Clause 36 state diagram

Adam Healey IEEE P802.3az Task Force Meeting Geneva, Switzerland May 2010

Proposed changes

Figure 36–7c—PCS Receive state diagram, part c (only required for the optional **EEE** capability) labeled circles on Figure 36-7a, and vice versa.

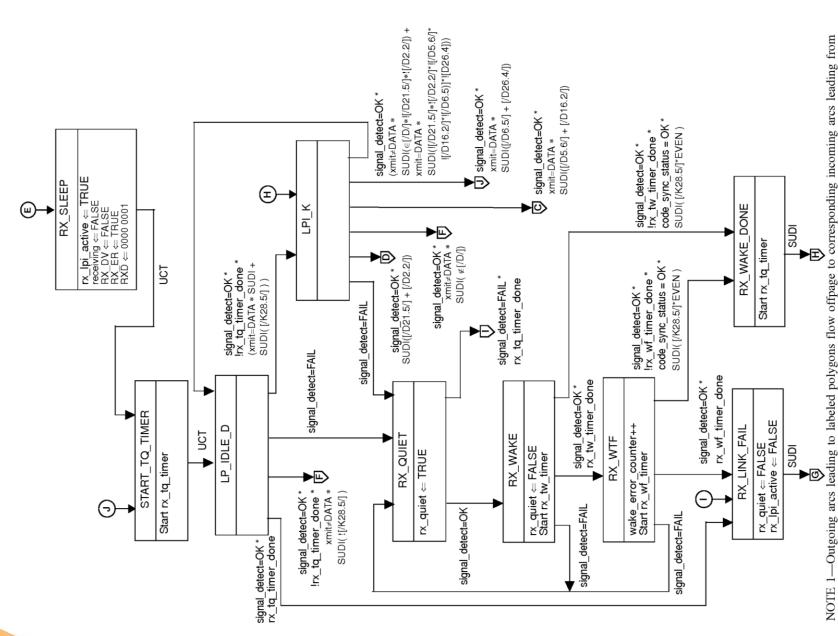
- Change the state diagram as shown on the next slide
- Delete rx_ts_timer definition from 36.2.5.1.7
- Remove T_{SR} row from Table 36-3b
